**Wichita-Sedgwick County
Metropolitan Area
Planning Department**

RE: CUP2025-00040 – Administrative Adjustment in the City to the Wiedemann Business Park Community Unit Plan CUP DP-88, to permit Warehouse, Self-Service Storage on Parcel 5, on property zoned GC General Commercial District; generally located on the south side of East Kellogg Drive and one-quarter mile west of South Greenwich Road (10727 E. Kellogg Dr.).

WIEDEMANN BUSINESS PARK

COMMUNITY UNIT PLAN DP-88

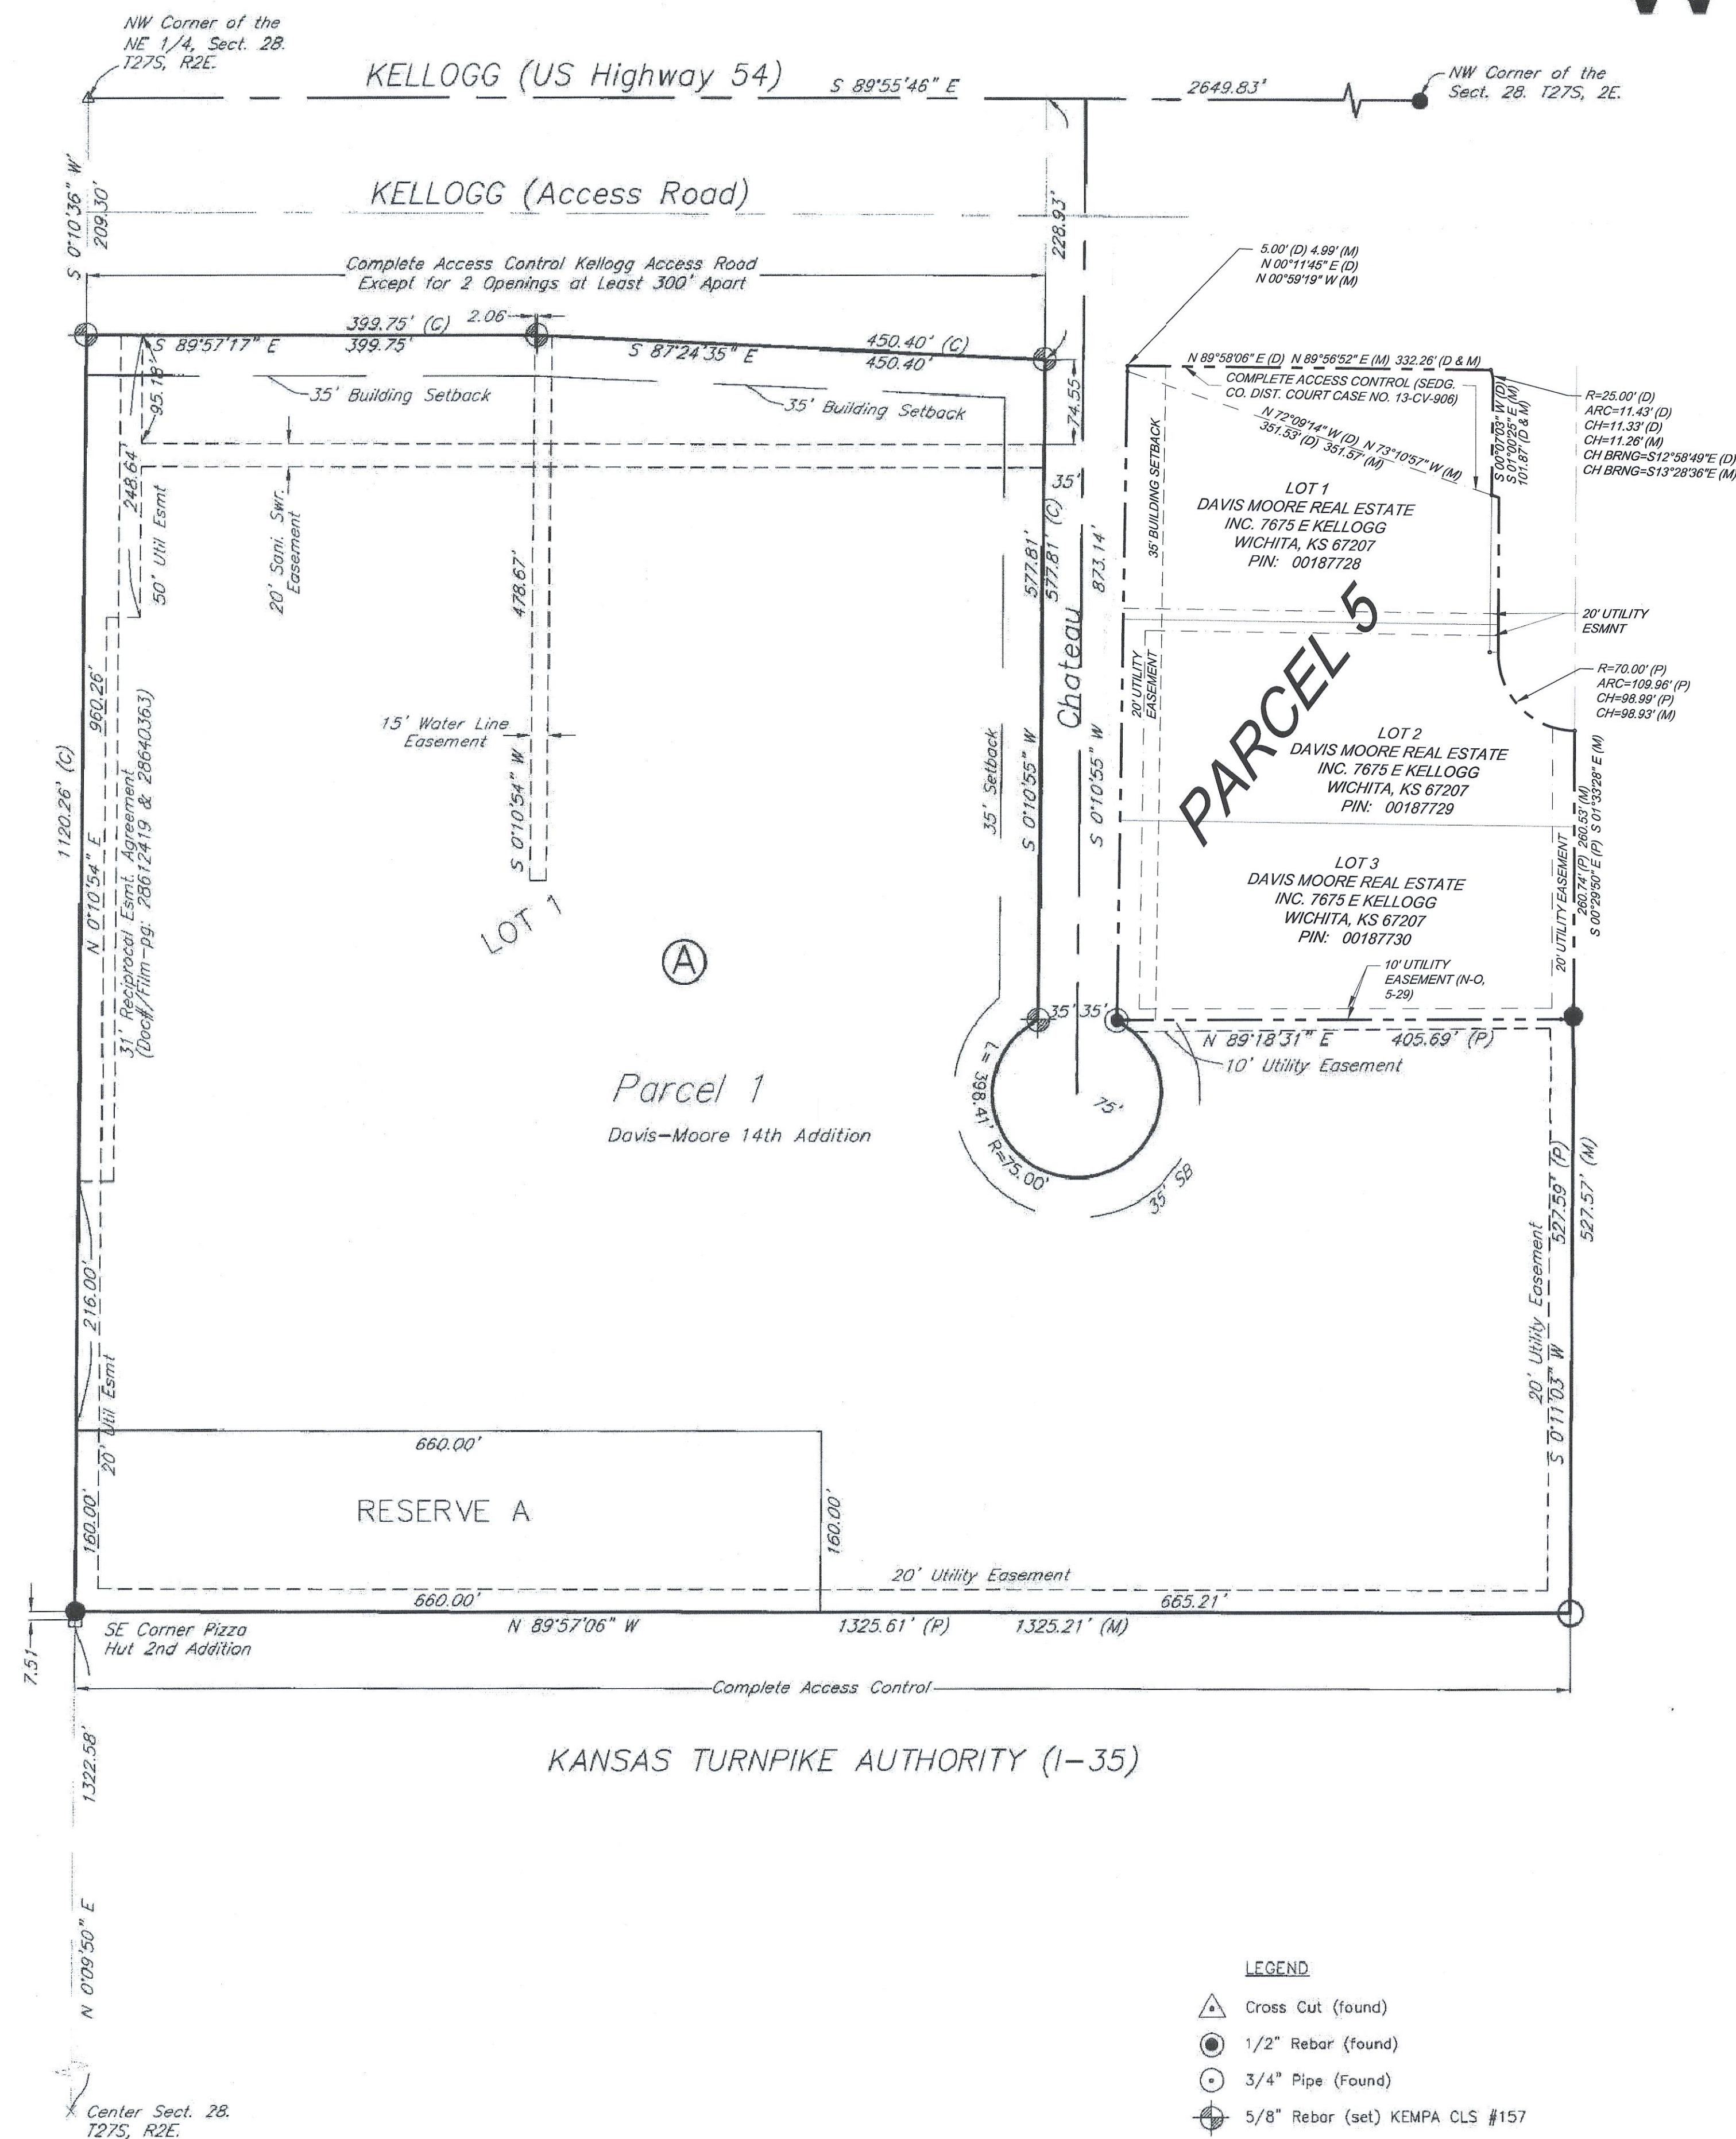
We received and reviewed your request for an Administrative Adjustment to CUP DP-88 to permit Warehouse, Self-Service Storage as a permitted use on Parcel 5. The subject site is zoned GC General Commercial District for which Warehouse, Self-Service Storage would typically be a use permitted by-right. The CUP does not specifically prohibit the proposed use. Furthermore, the proposed use is not deemed to be more intensive than existing, permitted uses within the CUP. The proposed uses for Parcel 5 include the following: Automotive, truck, recreational vehicle, mobile home, and marine sales and services; Indoor amusement enterprises; Offices; Restaurants; Warehousing; Wholesale; Distributors; Professional and Personal Services; Lumber Yards; and Sales of Retail merchandise.

General Provision 3 requires parking ratio to adhere to the Unified Zoning Code. The parking requirement for Warehouse, Self-Service Storage is 1 parking stall per employee plus 1 parking stall per 8,000 square feet of floor area but in no case shall there be less than 5 spaces. The proposed site plan identifies that the total storage area would be up to 105,000 square feet. Therefore, the total parking requirement is 13 spaces. The site plan illustrates 14 parking spaces.

Permitted Uses: Same as Parcel 1 **and Warehouse, Self-Service Storage.**

Floor Area Ratio: 45% or 99, 558 sq. ft., 50% or 110,620 sq. ft. for warehousing (**including Warehouse, Self-Service Storage**) or wholesale distributors.

On the basis of our review, we find that adjusting the CUP in the manner stated above is consistent with the approved CUP and will not have an adverse effect on the CUP or adjacent properties, nor will it be a substantial deviation of the original plan. Section V-E.14.c. of the Unified Zoning Code permits adjusting a CUP to permit uses that are not more intensive than the other uses approved as part of the CUP. Uses within the CUP are deemed to be compatible with the requested use of Warehouse, Self-Service Storage, and the proposed use is not considered more intensive than those already permitted. Permitting the use on Parcel 5 does not violate Section V-E.14.c. of the Unified Zoning Code.

COMMUNITY UNIT PLAN DP-88

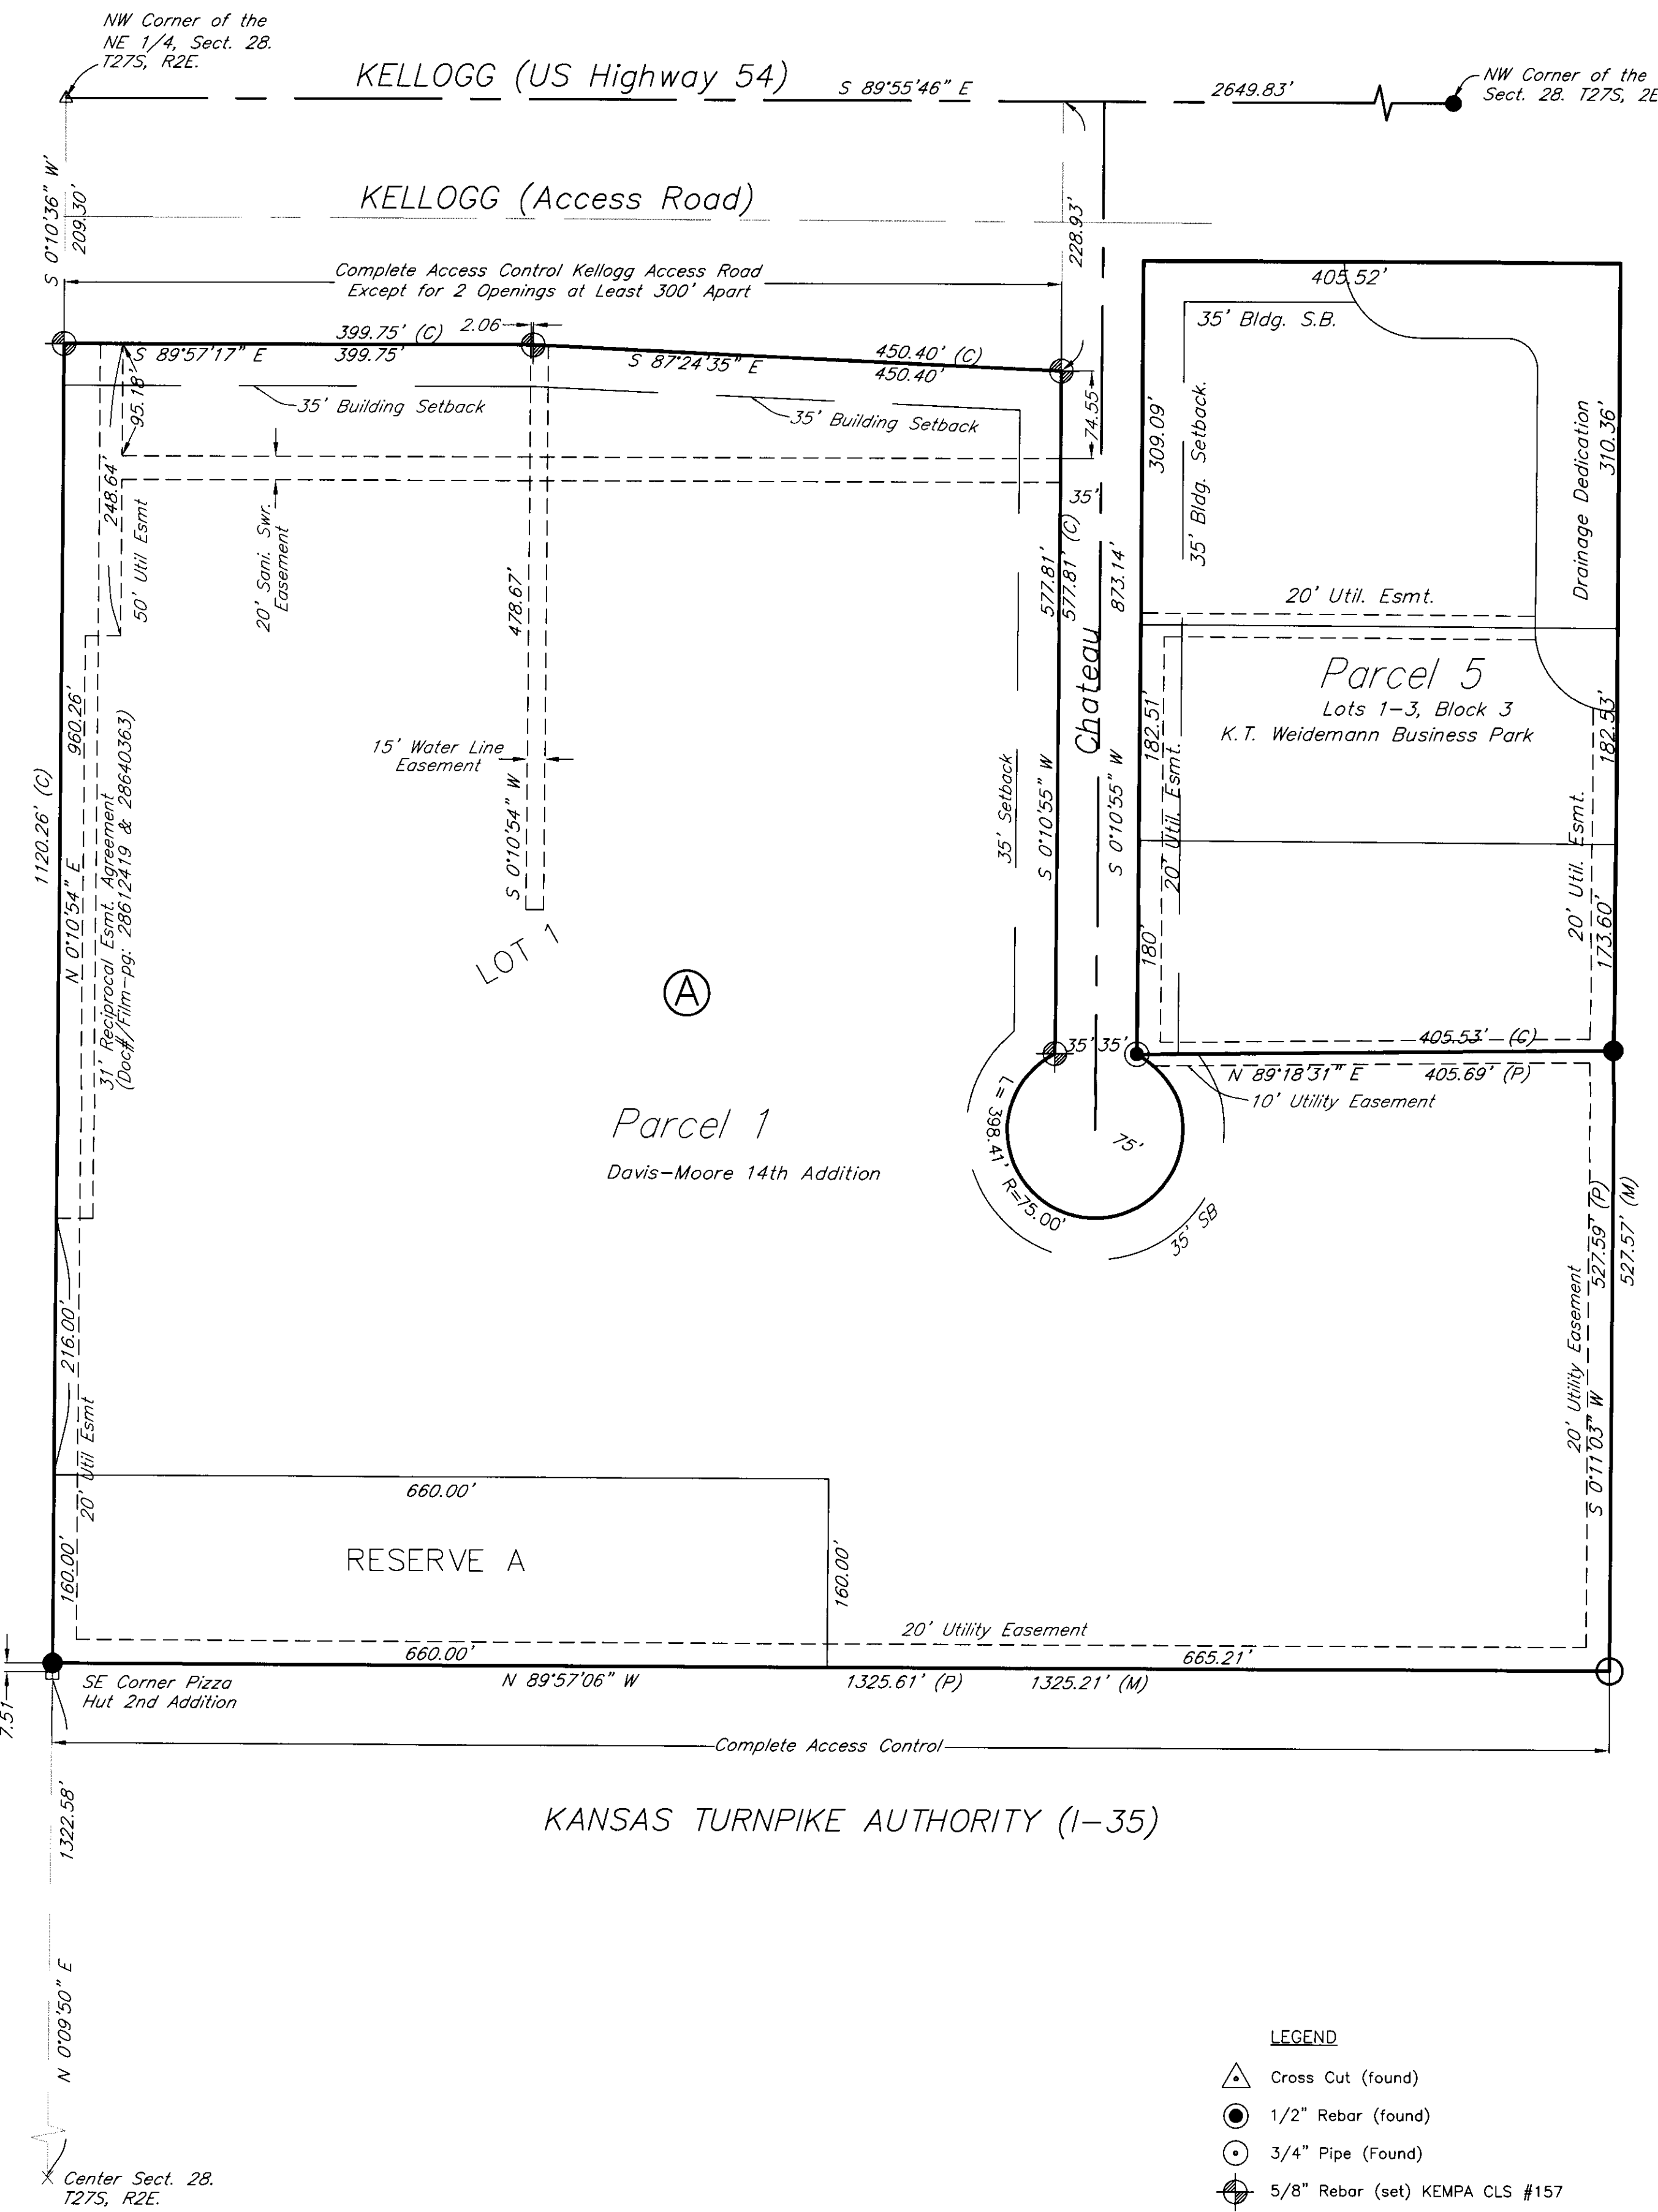
We received and reviewed your request for an Administrative Adjustment to DP-88 to alter the parcel boundary and area calculations of Parcel 5. Upon review of the Community Plan General Provision, staff found additional adjustments to outdated terminology that needs to be included in this adjustment. The following reflects the proposed modifications identified in red letters:

Floor Area Ratio: 45% or **99,558 sq. ft.**; 50% or **110,620 sq. ft** for warehousing or wholesale distribution.

Area = **5.08 Acres**

#7: Screening and Landscaping: A landscaped street yard adjacent to the Kansas Turnpike shall be provided with trees, grass and shrubbery not less than ten (10) feet in width, and otherwise in compliance with the landscape ordinance. Failure to maintain the landscape street yard shall be considered a violation of the C.U.P. after a joint determination by the Director of Planning and **the Zoning Administrator.**
~~Superintendent of Central Inspection.~~

A performance bond shall be posted with the **Zoning Administrator** ~~Superintendent of Central Inspection~~ guaranteeing the present cost of wall construction adjusted for inflation over a ten (10) year period...

On the basis of our review, we find that adjusting the CUP in the manner stated above is consistent with the approved CUP and will not have an adverse effect on the CUP or adjacent properties, nor will it be a substantial deviation of the original plan.
